File In Section: Product Recalls  
Bulletin No.: 09121  
Date: May 2009

# Recall Bulletin

**SUBJECT:** Positive Battery Cable Routing - Reroute

**MODELS:** 2010 Chevrolet Camaro  
Equipped with a V8 Engine

2271930

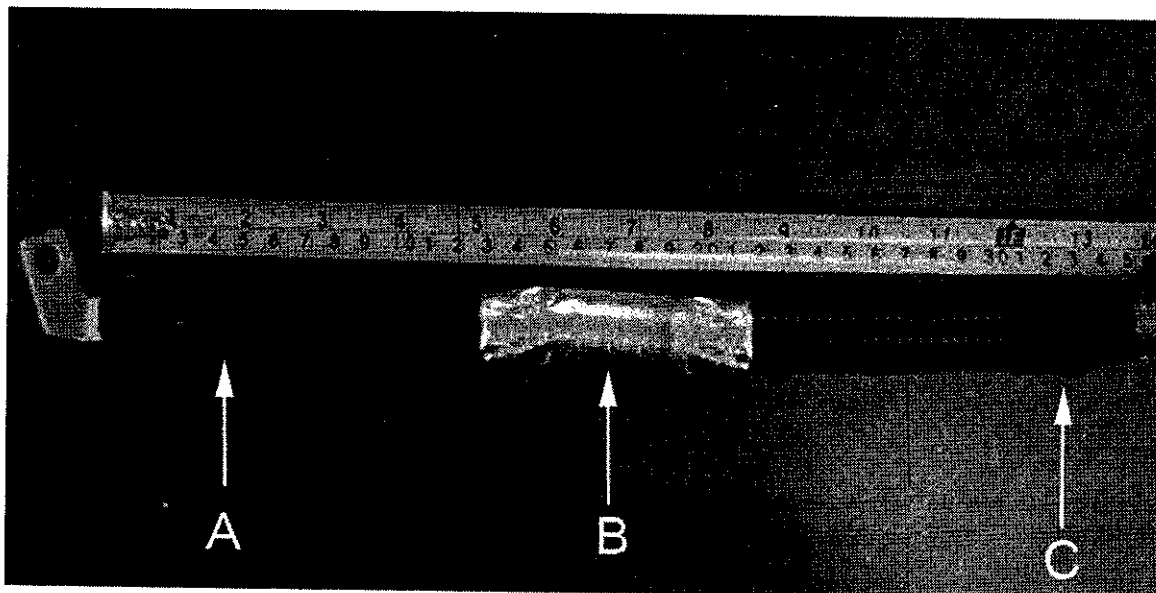
- (1) Battery Positive Starter Cable-to-Starter Contact Area
- (2) Motor Mount-to-Battery Positive Starter Cable Contact Area
- (3) Battery Positive Starter Cable
- (4) Starter
- (5) Motor Mount

4. Locate where the battery positive starter cable (3) contacts the starter (4) and motor mount (5). Refer to the illustration above.
5. Remove starter terminal nut and the battery starter cable from the starter terminal.
6. Move the battery starter cable away from the motor mount.

7. Use a hand file to round the edge of the motor mount (5) in the battery positive starter cable-to-motor mount contact area.

2272624

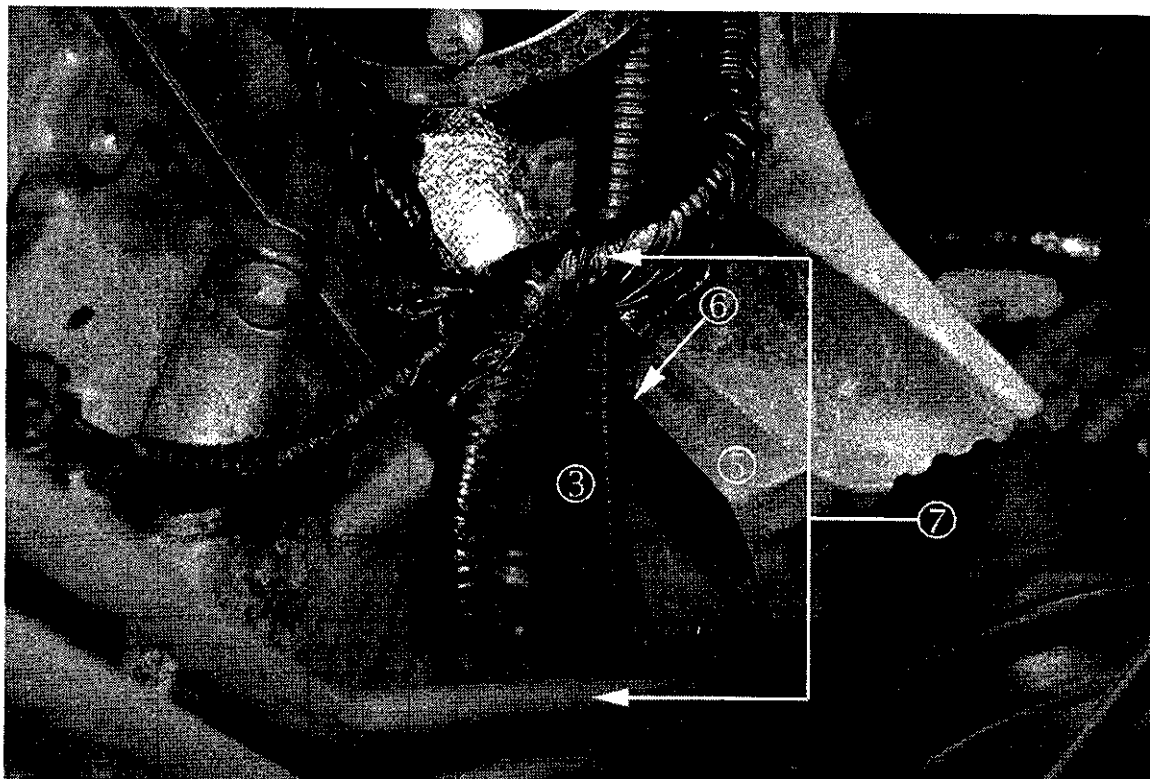
9. Pull the conduit forward to the terminal and tape it in place using Elliott EG190 tape (P/N 19117900 or 19117901 to be available in the future).
  - 9.1 Secure the conduit to the battery positive starter terminal with Elliott EG190 tape (P/N 19117900 or 19117901 to be available in the future).

- 9.2 Begin wrapping the tape at the terminal end of the battery positive starter cable and continue wrapping the tape 76 mm (3 in) forward toward the front of the vehicle.

- 9.3 Wrap the Elliott EG190 tape (P/N 19117900 or 19117901 to be available in the future) around the battery positive starter cable in the specified 76 mm (3 in) section of the cable (A) four times at 50 percent overlap.

- 9.4 Wrap the other end of the conduit that is forward of the motor mount (C) with the Elliott EG190 tape (P/N 19117900 or 19117901 to be available in the future) to secure the conduit to the channel.

2271927

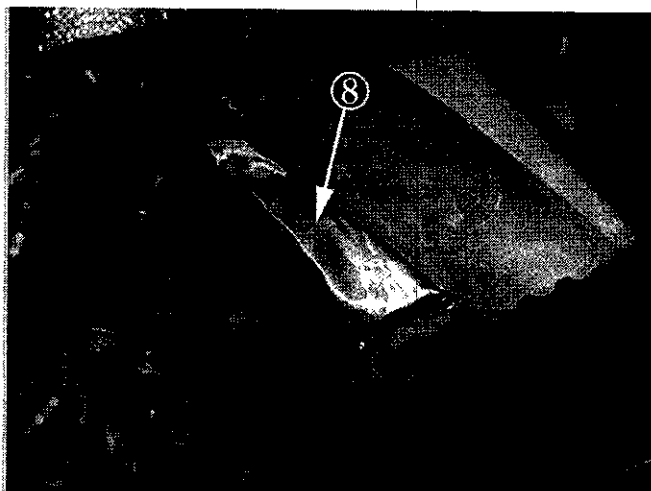
10. Wrap a piece of Polyken 342 tape, P/N 10184916, around the battery positive starter cable (3) in the motor mount contact area (6) of the cable. Wrap the tape around the cable until it is forward of the motor mount. The tape wrap area (7) should measure about 102 mm (4 in) in length. Wrap the tape in the motor mount area 3 times at 50 percent overlap.
11. Cut a 50 mm (2 in) X 127 mm (5 in) piece of butyl patch, P/N 25757810.
12. Clean the motor mount contact area (6) with 50/50 water isopropyl alcohol solution and a shop towel.

2272630

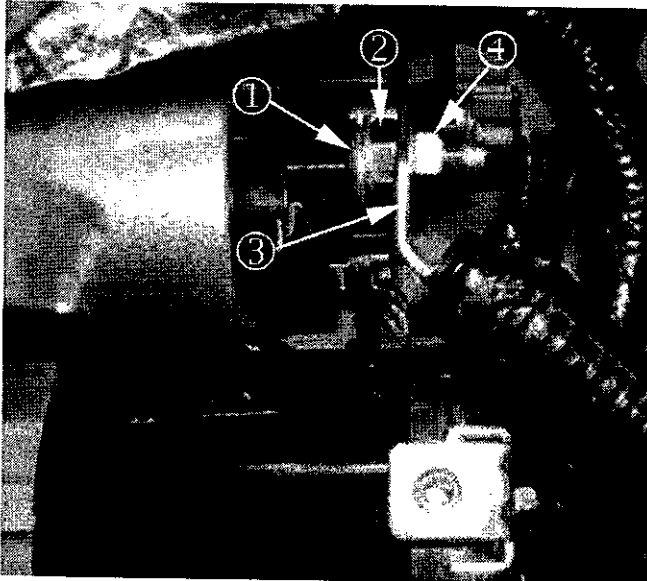
13. Apply the butyl patch (8) to the contact area of the motor mount (6).

2271928

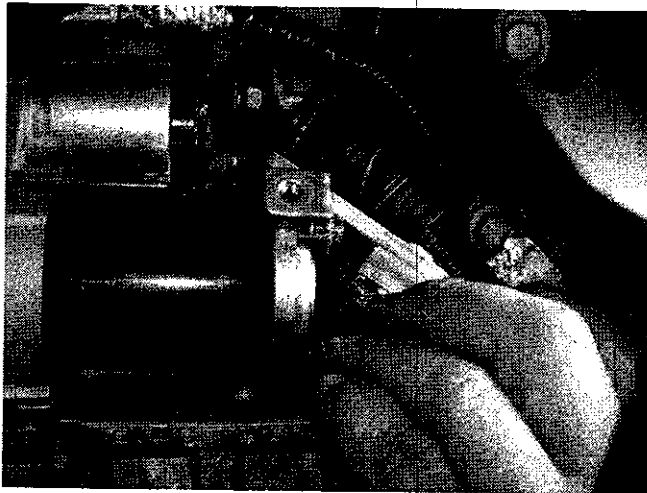
14. Install the battery positive starter cable to the starter terminal.

14.1 Install two copper washers (1), P/N 21012386, and brass nut (2), P/N 21021808, to terminal.

14.2 Tighten brass nut (2) to 11 N·m (8 lb-ft).

14.3 Install the battery positive starter cable (3) to starter terminal.

2272626

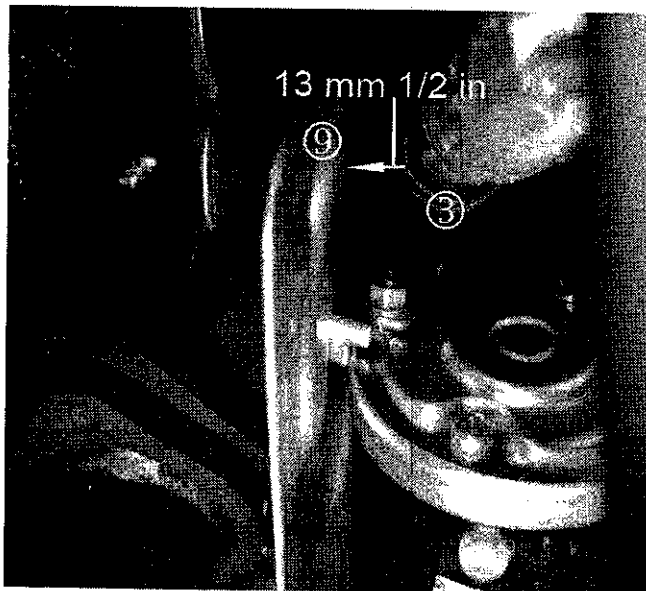
14.4 Ensure that there is a 4 mm (0.16 in) clearance between the starter and the battery positive starter cable.

14.5 Install and tighten production terminal nut (4) to 11 N·m (8 lb-ft).
